CAVENDISH ER BRF 0146 (13)
CONTRACTOR FABRICATED PRE-CAST

___ No Exception Taken
___ Make Correction as Noted
___ Submit Specified Item
X Revise and Resubmit as Noted
___ Rejected

CAVENDISH ER BRF 0146(13)

COVER SHEET/INDEX

ABUTMENT 1 PLAN&ELEV VIEW

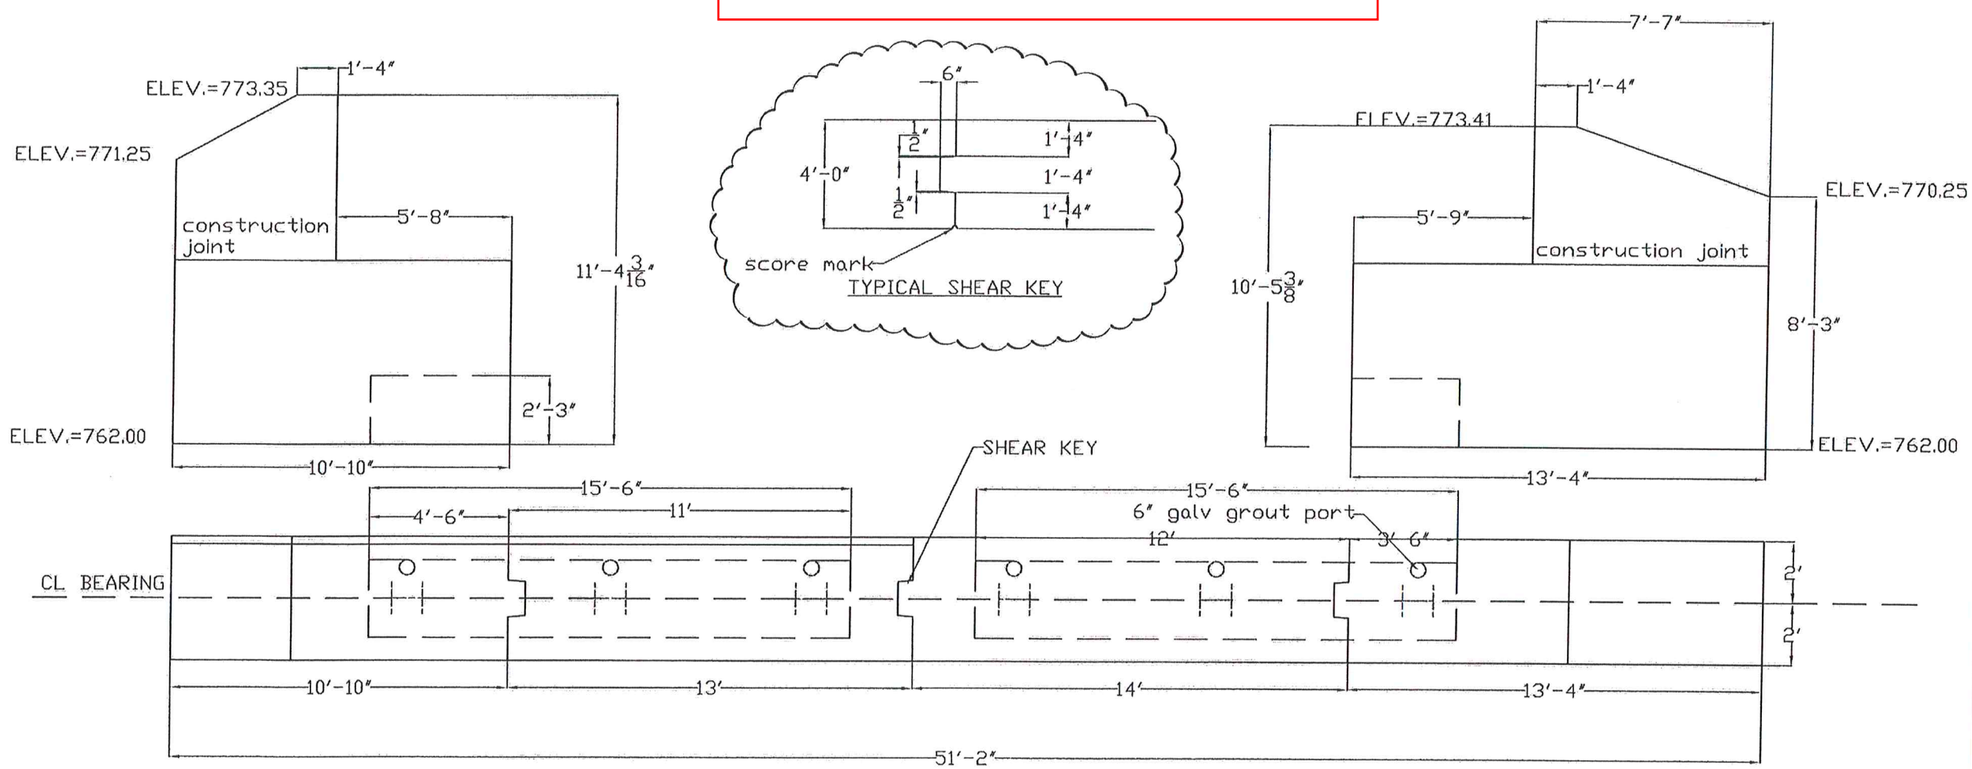
WHAT TYPE OF EPOXY WILL BE USED AT THE SHEAR KEYS?

REINFORCING PLAN

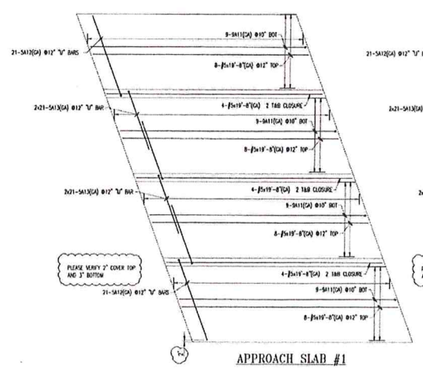
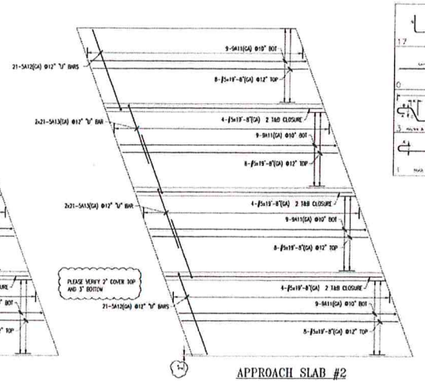
PLEASE VERIFY COVER AND LAP OF DWL BARS

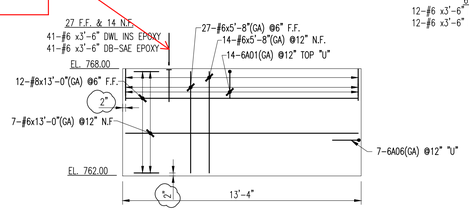
WHY ARE COUPLERS USED BETWEEN WING AND SUPERSTRUCTURE CLOSURE?

THESE DOWELS WILL CONFLICT WITH GIRDERS

ALL VERTICAL BARS EXTENDING FROM TOP OF ABUTMENT ON FRONT FACE NEED TO BE SPACED TO AVOID CONFLICTS WITH GIRDERS (TYP ALL PRECAST ABUTMENT SEGMENTS)

THESE BARS WILL PROTRUDE OUT THE TOP OF THE WINGWALL

NOT SURE WHAT NEEDS TO BE VERIFIED

THESE DOWELS WILL CONFLICT WITH GIRDERS

THESE BARS WILL PROTRUDE OUT THE TOP OF THE WINGWALL

THE TYPE OF COUPLER INTENDED FOR USE AND SUPPORTING TECHNICAL INFORMATION NEEDS TO BE PROVIDED WITH THIS SUBMITTAL.

3 ADDITIONAL MECHANICAL COUPLER SETS OF EACH SIZE AND TYPE USED ON THE PROJECT NEED TO BE PROVIDED TO THE AGENCY FOR TESTING PURPOSES.

LAP OF VERTICAL BARS EXTENDING FROM PRECAST ABUTMENT MATCHES CONTRACT DESIGN PLANS.

ENGINEERING OF LAPS/DEVELOPMENT LENGTHS NOT PRESENT IN CONTRACT PLANS IS RESPONSIBILITY OF CONTRACTOR

APPROACH SLAB #1

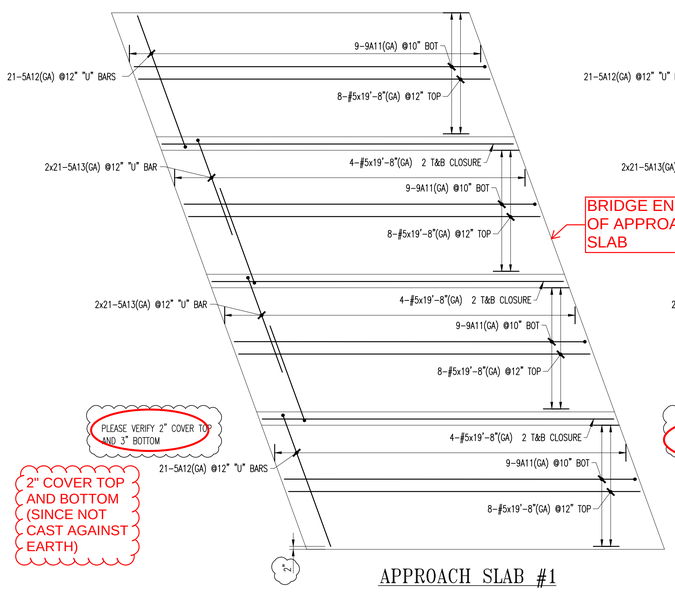
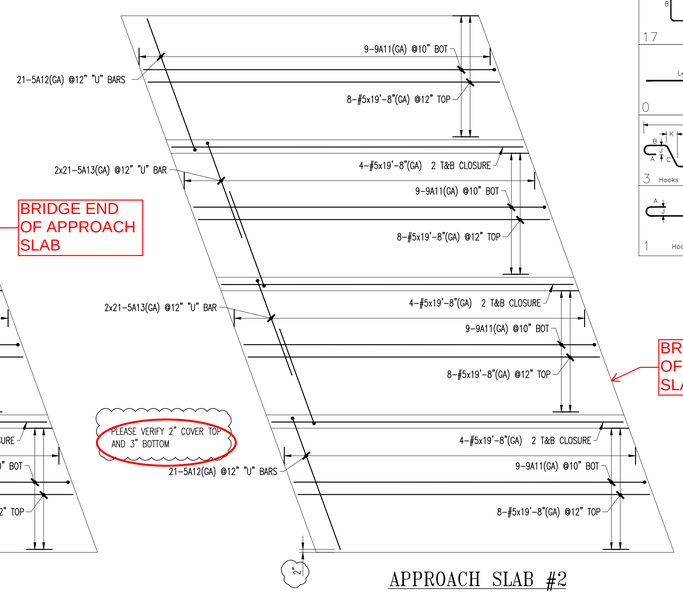
2" COVER TOP AND BOTTOM (SINCE NOT CAST AGAINST EARTH)

NEED TO IDENTIFY ASTM SPEC AND GRADE (NEEDS TO MEET ASTM A 1055 WITH A MINIMUM YIELD STRENGTH OF 60 KSI)

ABUTMENT 2 BEARING LAY-OUT

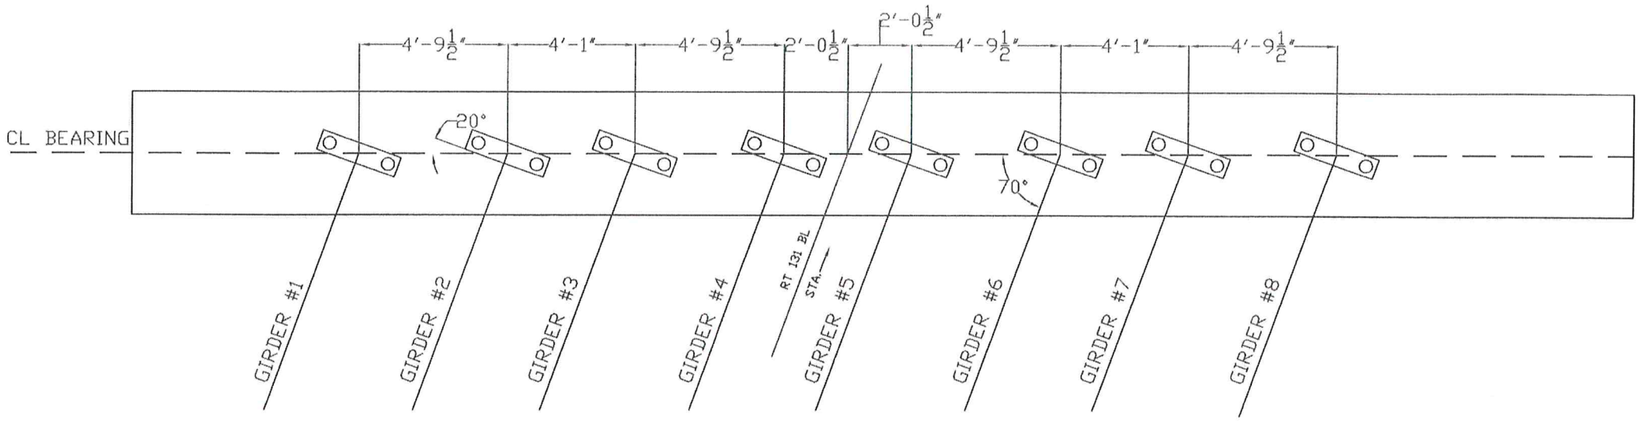
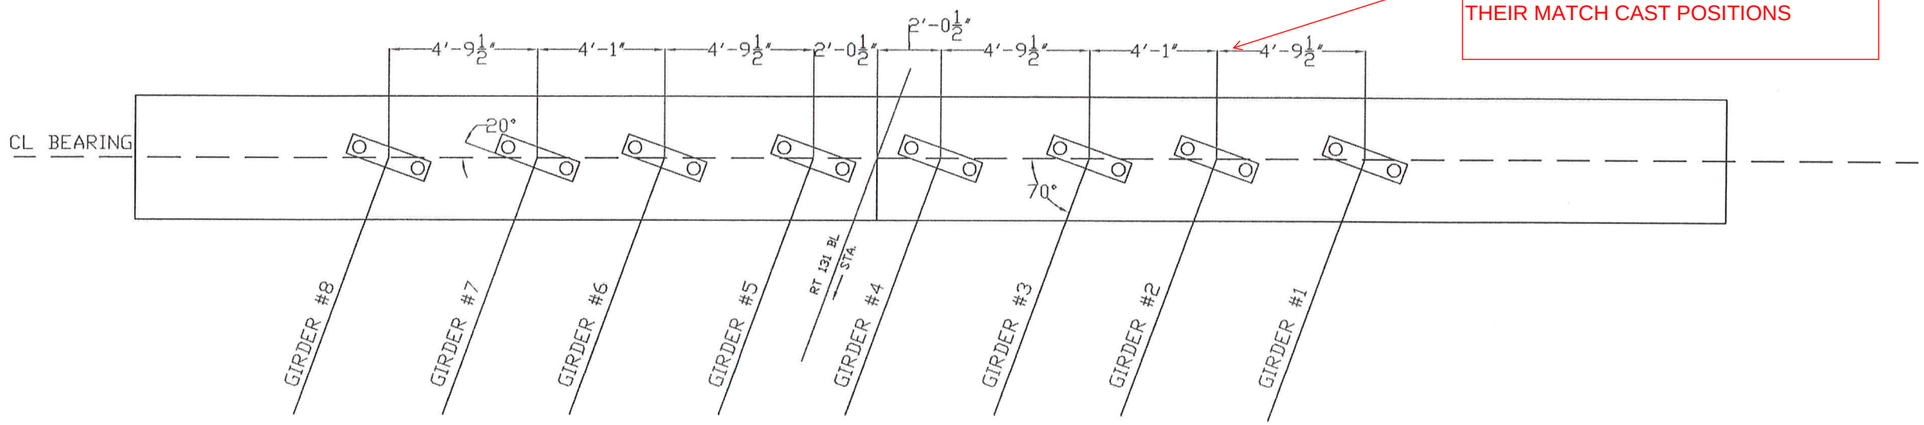
THESE SHOULD BE TIED TO THE SHEAR KEY LOCATIONS SINCE THEY WILL OCCUR IN SEPARATE PIECES AND PERHAPS AFTER BEING MOVED FROM THEIR MATCH CAST POSITIONS

TYPICAL BEARING LAY-OUT DETAIL

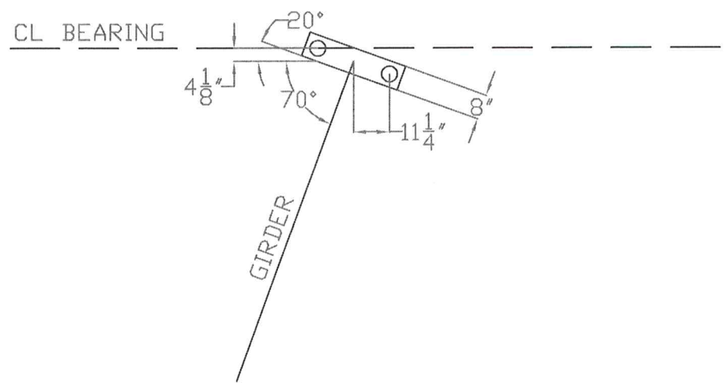
THERE IS ONLY ABOUT 6" CLEAR FROM THE EDGE OF AN ANCHOR ROD TO A PROPOSED SHEAR KEY. CONSIDERING THE DIAMETER OF THE HOLE NEEDED TO DRILL AND GROUT AS WELL AS THE REQUIRED EMBEDMENT DEPTH, CASTING CORRUGATED BLOCKOUTS FOR THE ANCHOR RODS MAY BE MORE PRACTICAL TO AVOID DAMAGE OR POTENTIAL SPALLING TO THE SHEAR KEY.

IT'S MY UNDERSTANDING THAT COLD RIVER BRIDGES MAY SLIDE THE PBU'S INTO POSITION FROM A TEMPORARY ADJACENT SUPPORT. HOW WILL THIS BEARING ASSEMBLY BE USED WITH THE PROPOSED SLIDING TECHNIQUE?
